SUBJECT: Savannah River Site's Responses to the Regulatory Comments on the Groundwater Report for the P-Area Groundwater (PAGW) Operable Unit (OU) April 2019 through March 2020 Data (SRNS-RP-2020-00621, Revision 0, October 2020) SEMS Number: 81

SRS Responses to the U. S. Environmental Protection Agency's Comments on Groundwater Report for the P-Area Groundwater (PAGW) Operable Unit (OU) (U) April 2019 Through March 2020 Data, SEMS Number: 81, SRNS-RP-2020-00621, Revision 0, October 2020

USEPA Comments Received February 26, 2021

Figure 1. DPT, CPT, and Isoflow Locations for the 2010/2011 Investigation of PAGW OU

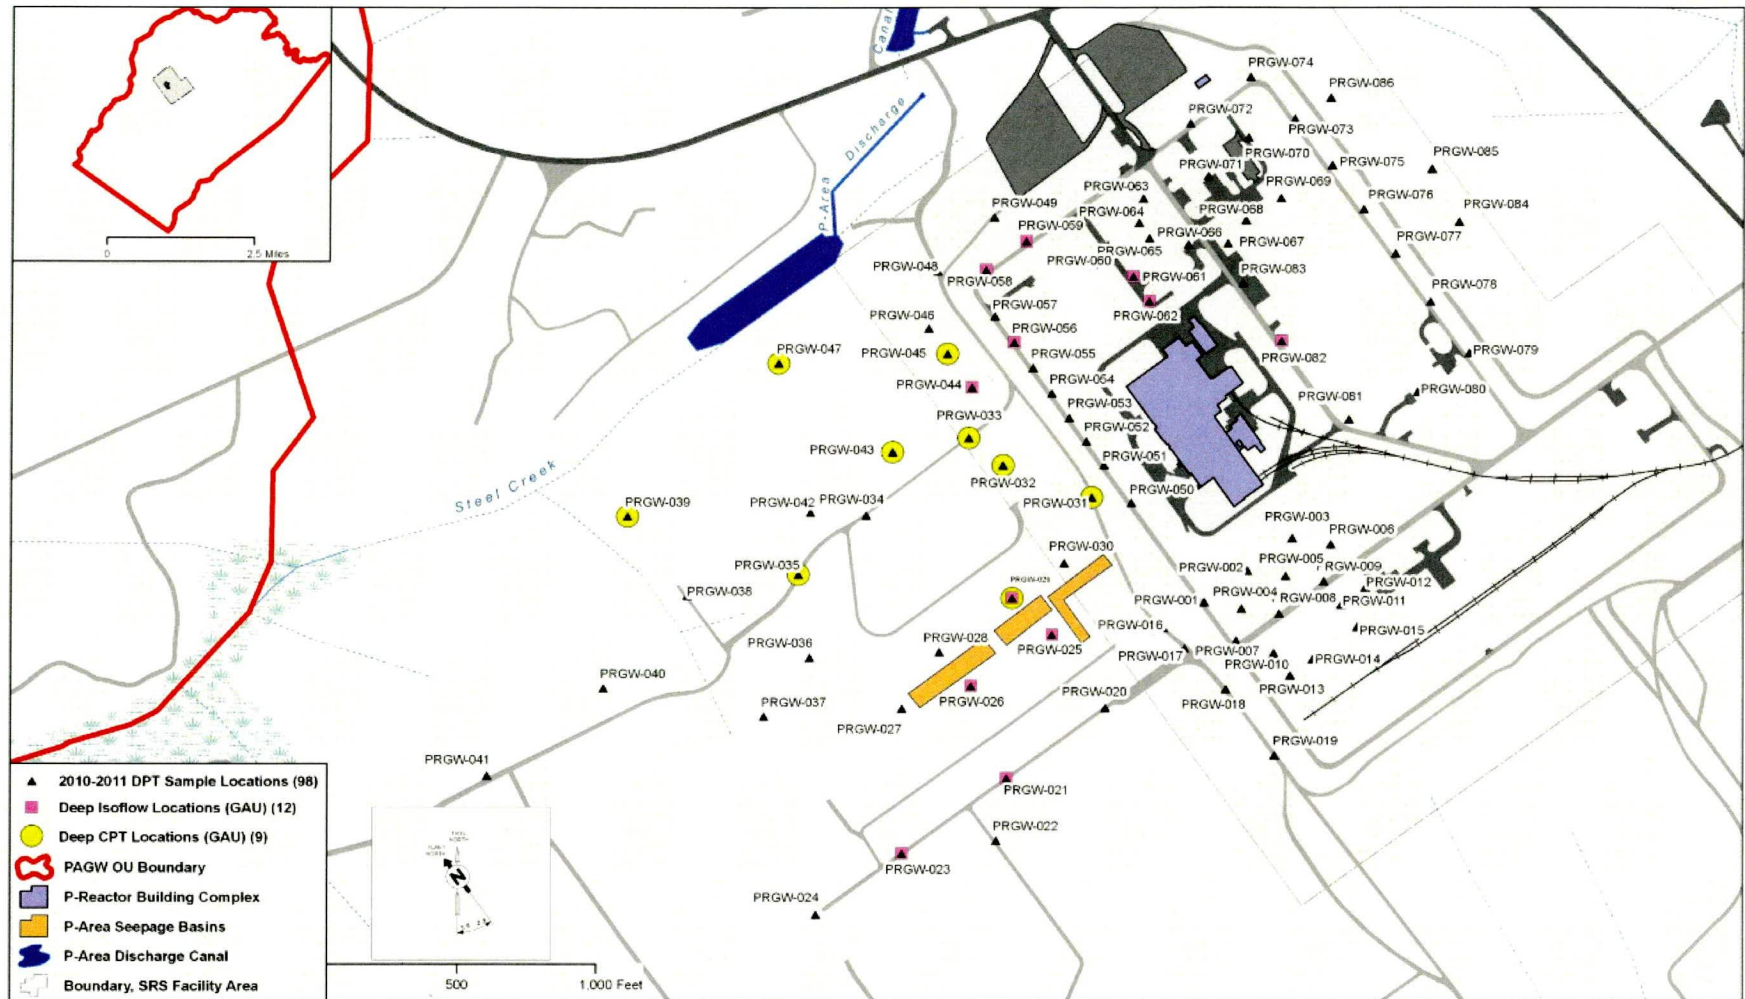
- The lateral extent of tritium contamination is poorly defined in the GA at wells PSB002AA and PSB002AL. For example, as seen in Figure 32. Gordon Aquifer Tritium Plume for the P Area Groundwater Operable Unit, GA wells PSB002AA and PSB002AL measured tritium at a concentration of 5680 pCi/mL and 47 pCi/mL, respectively. However, since no monitoring wells are located downgradient of PSB002AA and PSB002AL the lateral extent of tritium contamination in the GA is unknown.

SRS believes monitoring in P Area is sufficient to provide long-term monitoring of the groundwater plumes. As previously discussed in Core Team meeting in 2013 and 2017 and documented in the 2013 Sampling and Analysis Plan (SAP), a groundwater investigation effort in 2010/2011 was completed to address groundwater data gaps which included delineation of horizontal and vertical groundwater contaminant extent in the Upper Aquifer Zone (UAZ), Lower Aquifer Zone (LAZ), and Gordon Aquifer (GA) (SRNS 2011). Specifically, this investigation led to detections of tritium in the LAZ, Gordon Confining Unit (GCU), and GA at the P-Area Reactor Seepage Basins. Detection of tritium was limited to the PSB 2 well cluster. The extensive investigative effort from 2010/2011 is illustrated in Figure 1 for direct push technology (DPT), cone penetrometer technology (CPT) and Isoflow locations. Figure 2 depicts installed monitoring wells completed as an outcome of the investigation. In the 2013 scoping meeting, this finding was discussed, and a SAP was developed to further address this data gap. Field work in support of the 2013 SAP included sampling at three GA locations in the vicinity of PSB 2, installation of three GA monitoring wells, and retrofitting of PGW03A to monitoring well status (SRNS 2013). Figure 3 presents the locations of the 2013 SAP investigations. In January 2017, a scoping meeting was held to discuss the completeness of the 2013 SAP and it was agreed that work was complete, and no further investigation was warranted (SRNS 2017).

The 2010/2011 and 2013 groundwater investigations found no evidence of tritium in the GA beyond the PSB 2 well cluster. Sampling at newly installed wells in the GA also found no evidence of tritium. Therefore, the extent of tritium contamination in the GA is localized around the PSB 2 well cluster, with future monitoring of the existing GA network to continue.

Figure 4. Soil Boring Locations in Support of the 2018 SAP Investigation of the PAGW OU

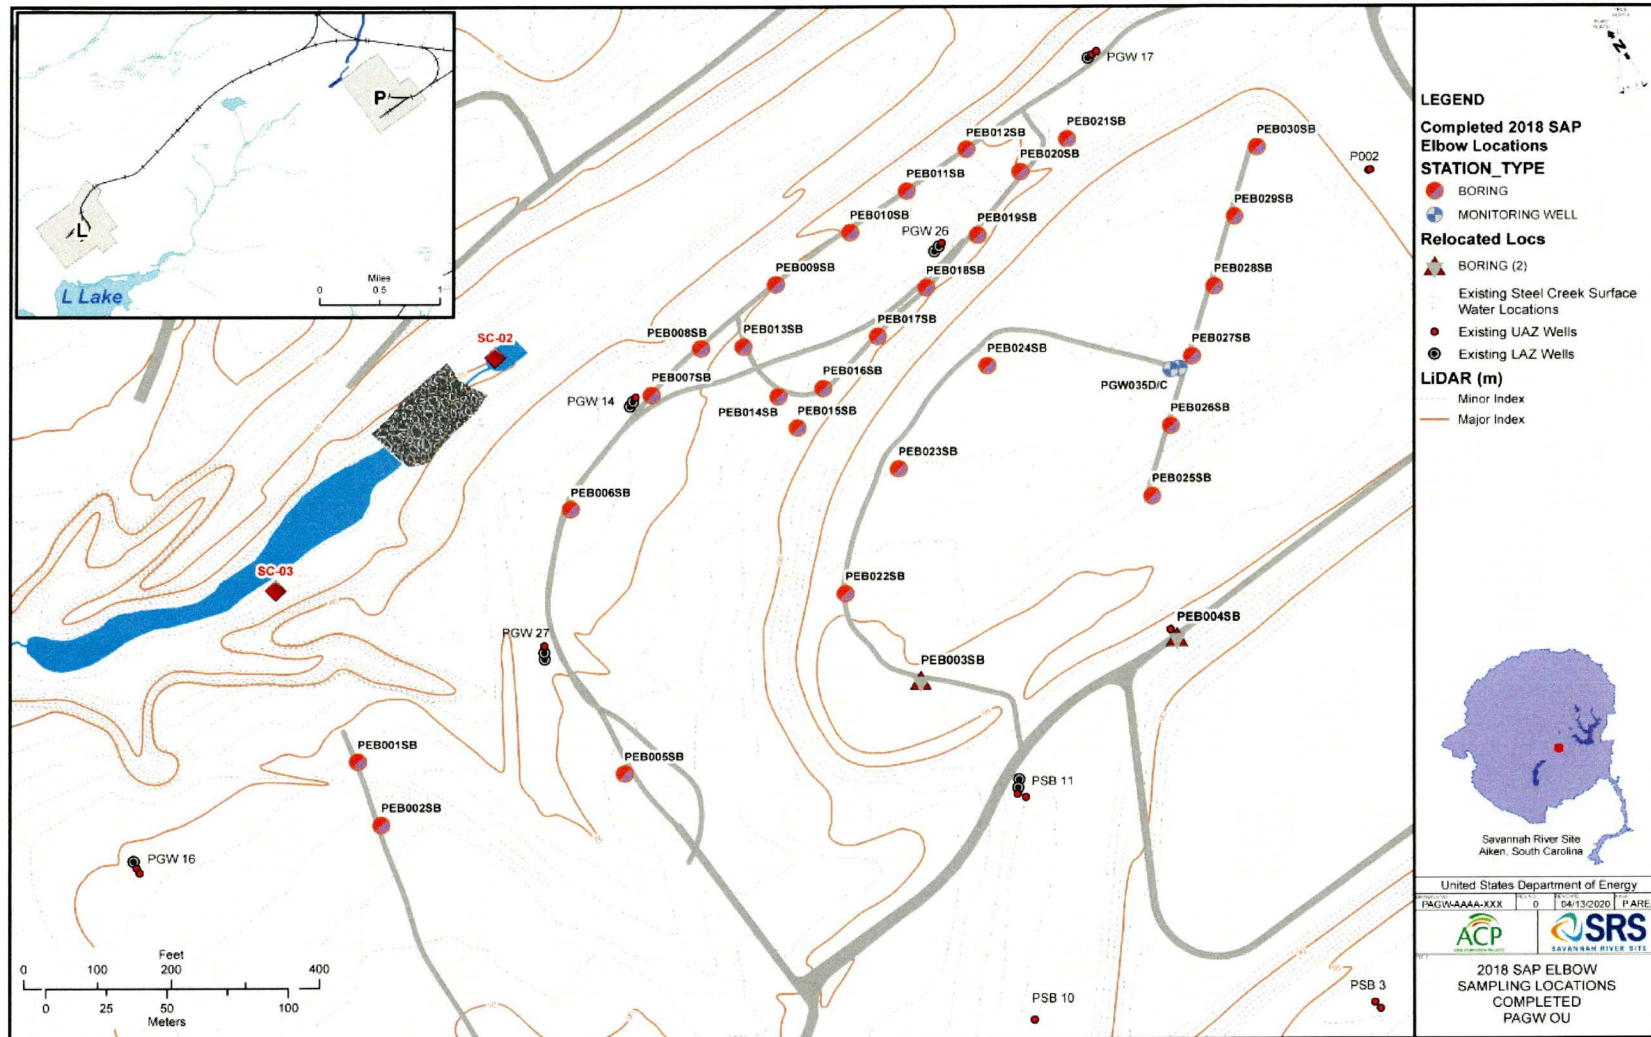
- The vertical extent of trichloroethylene (TCE) contamination is not defined at LAZ well PGW027C. As seen in Figure 38. Cross-Section of the Trichloroethylene Plume in P Area, TCE was measured at 173 micrograms per liter ($\mu\text{g/L}$) in PGW027C; however, no wells are monitored deeper than PGW027C to define the vertical extent of TCE contamination in the LAZ. Additionally, increasing TCE concentration trends are noted for LAZ wells PGW027C and PGW026B as seen in Figure 45. Time-Series Plots for Trichloroethylene at Distal Area Wells in the Lower Aquifer Zone.

SRS believes the proposed data gap of vertical TCE extent in the LAZ has been addressed through previous and most recently completed investigations and ongoing groundwater monitoring. Groundwater investigation in 2010/2011 included CPT and DPT sampling of the distal portion of the VOC and tritium groundwater plumes (SRNS 2011) (Figure 1). As an outcome, 21 new groundwater monitoring wells were installed to monitor the groundwater plumes. In addition, the 2018 SAP Addendum for the PAGW OU included multiple soil borings to investigate the extent of groundwater contamination in the elbow and distal portion of the VOC plume as depicted in Figure 4 (SRNS 2018). The 2018 SAP soil borings provided depth-discrete sampling in the vicinity of PGW027 and beyond towards the PGW016 well cluster. Findings of the 2018 SAP investigation show that TCE contamination does not extend to PEB001SB or PEB002SB borings, which are downgradient from PGW027. The findings were presented in a July 2020 data review meeting (SRNL 2020). Vertical extent of contamination has been investigated previously and the TCE plume is bounded by soils data combined with current groundwater monitoring. Additionally, existing monitoring well cluster PGW016 is down gradient of the PGW027 monitoring well cluster and no detection of groundwater contaminants have been observed.
